Bar pattern, level check

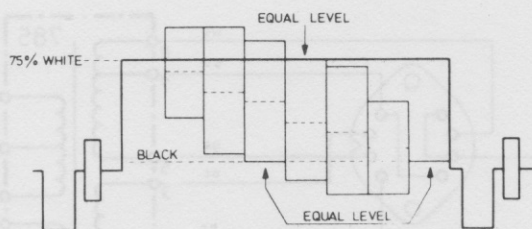
6. Please add and correct the check and adjustment procedure:

- Add to page 50, chapter 4.4.2., master oscillator, control voltage
 - o check duty cycle at pin 16/U1 to 0.45...0.55 (if necessary, correct by altering resistor 612/U1 to 64.9k...121kOhm and capacitor 510/U1 to 22N, ceramic plate)
- Correct page 52, chapter 4.5.2., Video amplitude 5th line:
 - If necessary, adjust with resistor 747/U10 in parallel to resistor 739/U10.
- Add to page 55, chapter 4.8.1., chroma amplitude:

4.8.1.1 Adjusting the 4th bar of the BAR-pattern

- Oscilloscope to connector VIDEO OUT
- Oscilloscope to trigger mode LINE
- Depress button BAR
- The 4th bar should have an amplitude which is the same as the amplitude of 75 % white. Adjustment is possible with potentiometer 823/U10.
- The 3th bar should be on the black level.
